Motor house and turbine interference EDIP 9500.0 / EDIP 6500.0

It is the aim of the present technical information to explain how to solve the interference problems between motor house and turbine in the above mentioned models.

Figure 1: Thermal cut out with and without plastic protection

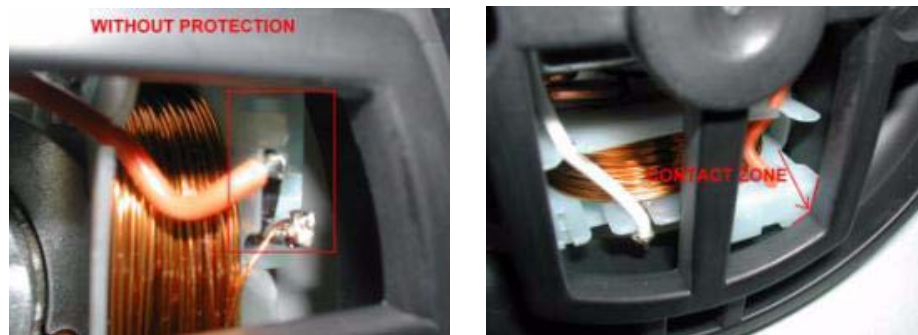
It was detected that one of the motor suppliers has been supplying motors with a plastic cover for protection of the thermal cut out. This protection does not allow a proper placement of the electric motor in the plastic motor base, so that the motor axis is not perpendicular to the plastic motor base. It makes the turbine to get out of its normal position interfering with motor house.

6. Finally, remove the thermal cut out plastic cover manually.

Figure 6: Remove the motor base

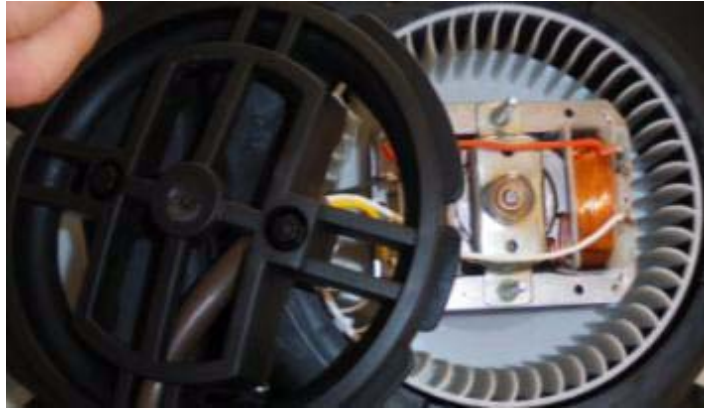
5. Remove the motor base so that you can access the plastic cover of the thermal cut out.
